HAY CREEK VALLEY EL PASO COUNTY, COLORADO 100% CONSTRUCTION DOCUMENTS. DETENTION POND GENERAL NOTES. DESIGNER: WCG, DRAWN: RWO, CHECKED: JAO, SCALE: 1"=200', DATE ISSUED: SEPTEMBER 2023, SHEET 18 OF 24, DRAWING No. DFGN01.

HAY CREEK VALLEY
EL PASO COUNTY, COLORADO
100% CONSTRUCTION DOCUMENTS

DETENTION POND 1 SITE PLAN

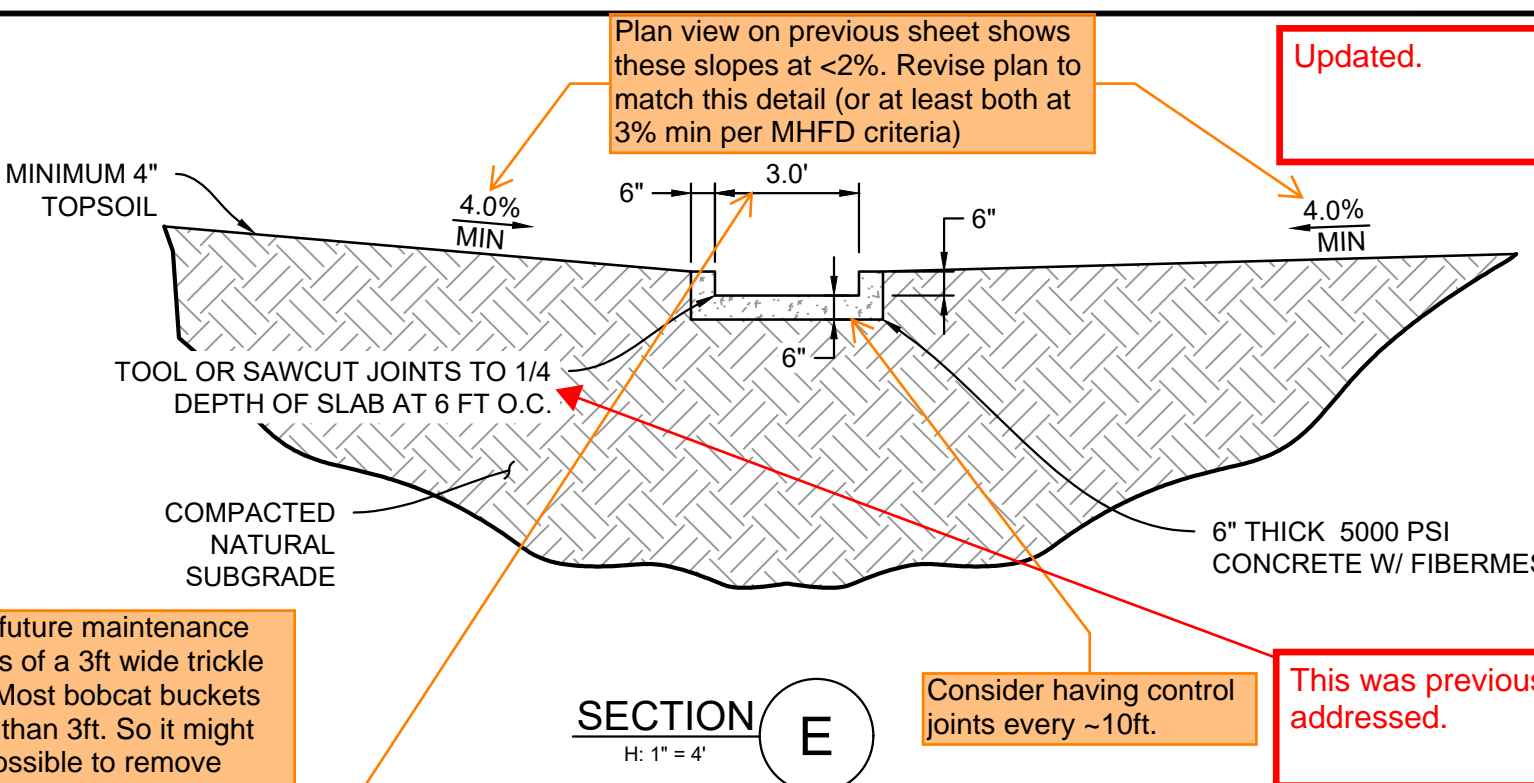
Internal note: review forebay design once forebay sizing calcs are provided in the FDR with the next submittal.

NOTED

30" RCP PENETRATION DETAIL

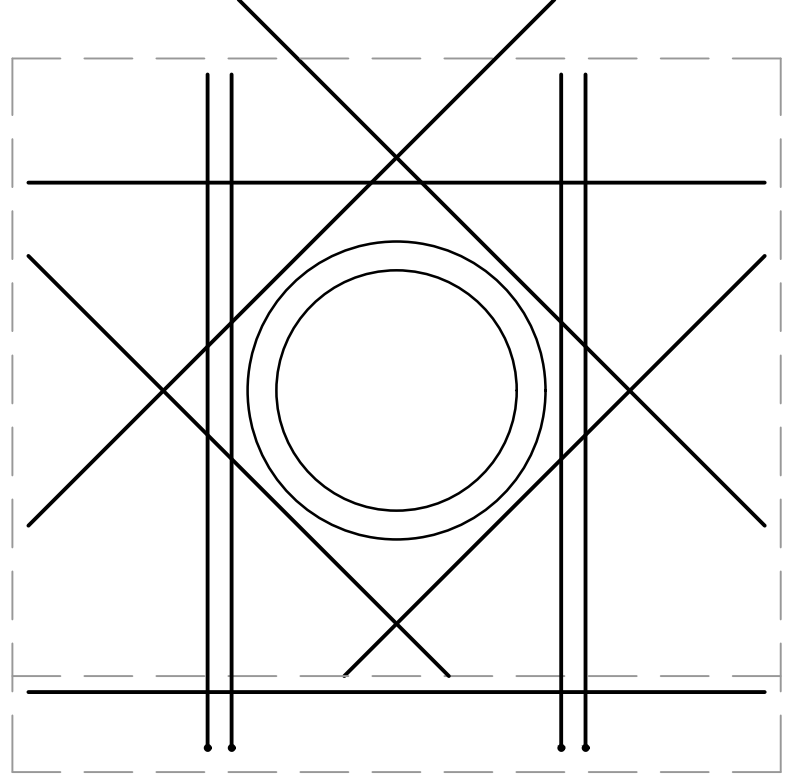
Consider future maintenance challenges of a 3ft wide trickle channel. Most bobcat buckets are wider than 3ft. So it might only be possible to remove sediment from the ~300ft long trickle channel via hand tools, which is a significant maintenance effort. Just a common note we have received from many pond end-users who wish their trickle channel was wider.

Client does not want channel to be wider than 3 feet.

Show dimension of other direction since it isn't shown on this detail or the plan view to the left.

Note: extending the riprap to the top of the forebay wall will not be possible adjacent to the trickle channel since the trickle channel is so much lower than the top of the forebay wall. Provide detail on how this transition will occur or modify the design.

Dim added.

Clarification added to plan view.

FOREBAY STEM WALL ELEVATION

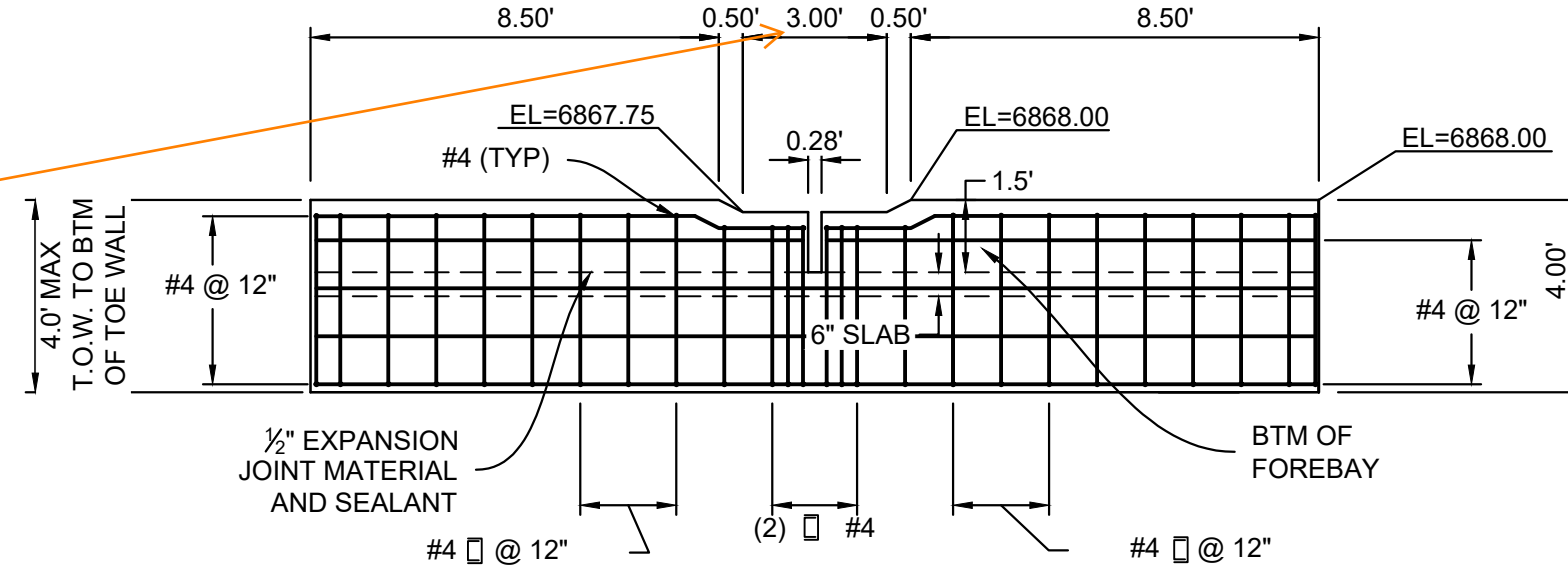
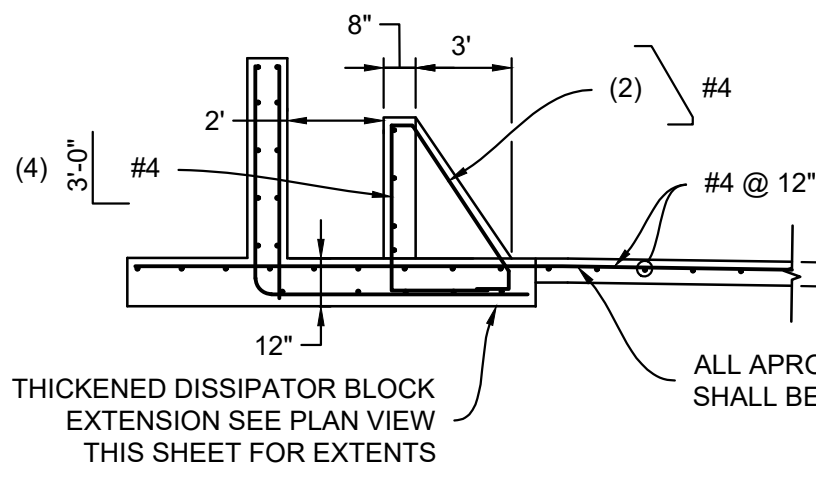
Revise such that these two details match.

Details have been updated.
